## SERVICE BULLETIN

ENGINE - MAIN GEARBOX ASSEMBLY NEW DEOILER ROLLER BEARING - CATEGORY CODE 7 -  
MOD.ENG-72-0299

# V2500-ENG-72-0299

Deoiler Roller Bearing  
Fig.1

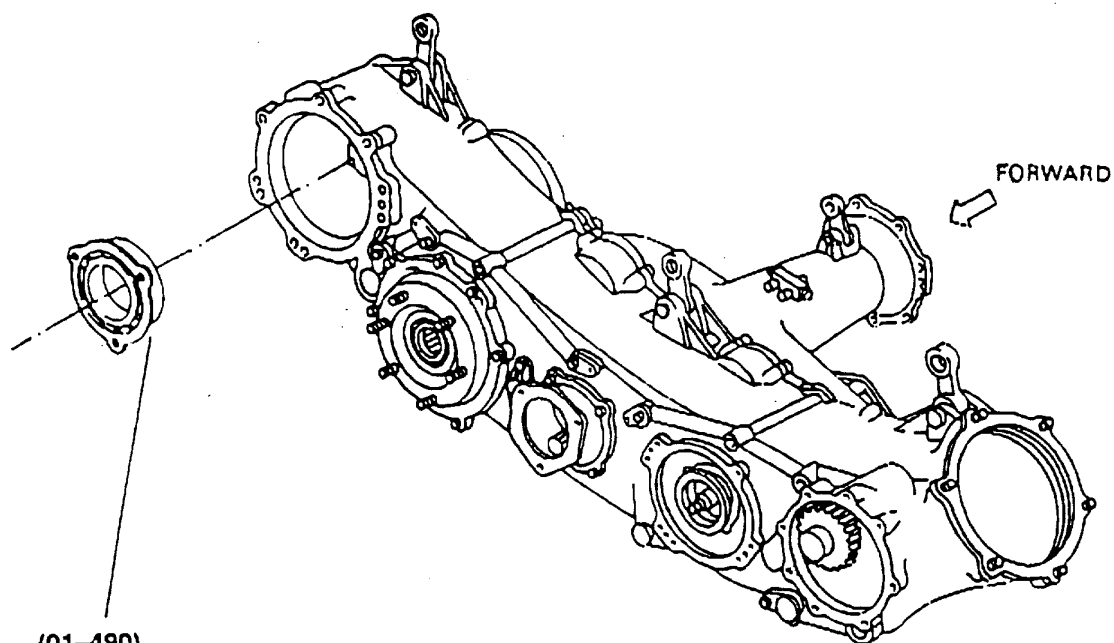
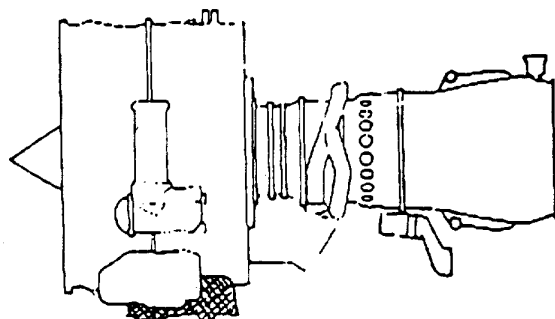
This Service Bulletin introduces a new Deoiler Roller Bearing, with the changes that follow:

(1) A new bearing clearance.

(01-490)  
BEARING, ROLLER

OLD P/N 4T0100  
NEW P/N 4T0105 (IC)

OLD P/N 4T0101 (ALT)  
NEW P/N 4T0106

OLD P/N 4T0103 (ALT)  
NEW P/N 4T0108
